August 26, 2022

The Washington Park Conservancy would like to express our appreciation for the opportunity to take part in the Washington Park Complete Streets Traffic Study. This important project highlights the impact from traffic in and around the park and works to improve cycling and pedestrian safety for park visitors and residents in the surrounding neighborhoods. Your administration's dedication to the city's network of parks is an important investment in the long-term health and vitality of the city for its residents. We'd also like to express our appreciation for the city's traffic engineering division and the numerous consultants at Creighton Manning. The time invested in the planning of multiple public comment periods, stakeholder meetings, and project briefs allowed for a wide range of comments from all interested parties which will only make the final plan comprehensive and more meaningful for residents and visitors alike.

We've had the opportunity to review the draft plan and would like to provide specific comments on each of the areas outlined in the draft report. Not surprisingly, we are supportive of many of the proposed changes with a few suggestions for potenti

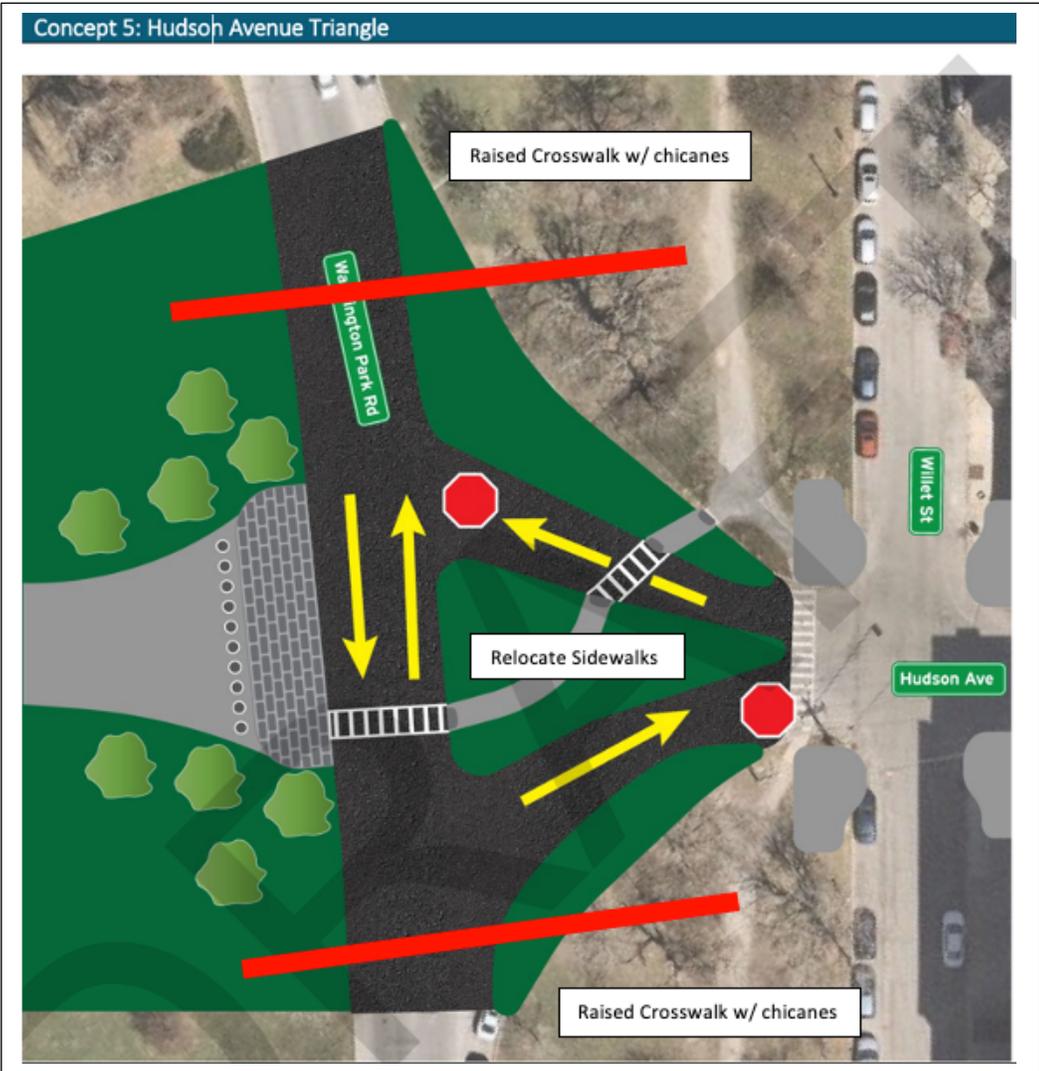
- a. We recommend aligning the sidewalk from Englewood Place, south to north, to the existing crosswalk at Western Avenue. This will maintain existing pedestrian sight lines and anticipate how pedestrians will traverse this area. We feel that the rightward jog will not be utilized properly, as pedestrians will walk in the most direct route possible. (Below in red)

- b. We recommend continuing the existing sidewalk from Western Avenue onto the existing State Street sidewalk on the south side of the new intersection. Again, this will maintain existing pedestrian sight lines and anticipate how pedestrians will traverse this area from west to east. (Below in red)

- c. There was also discussion about the ability to pull the peninsula of lawn between the inner park road and Englewood Place. north towards the Western Avenue intersection. We feel this would provide another way to give back land to the park border, help simplify the reworked intersection changes, and, importantly, protect pedestrians entering the park from this corner. This corner of the park is another significant entrance point for playground visitors so improvements to the safety and layout of this intersection is imperative.

- d. On Washington Park Road moving south to north, we recommend a larger curb extension at the corner to narrow the intersection and dissuade traffic from going by the playground area.
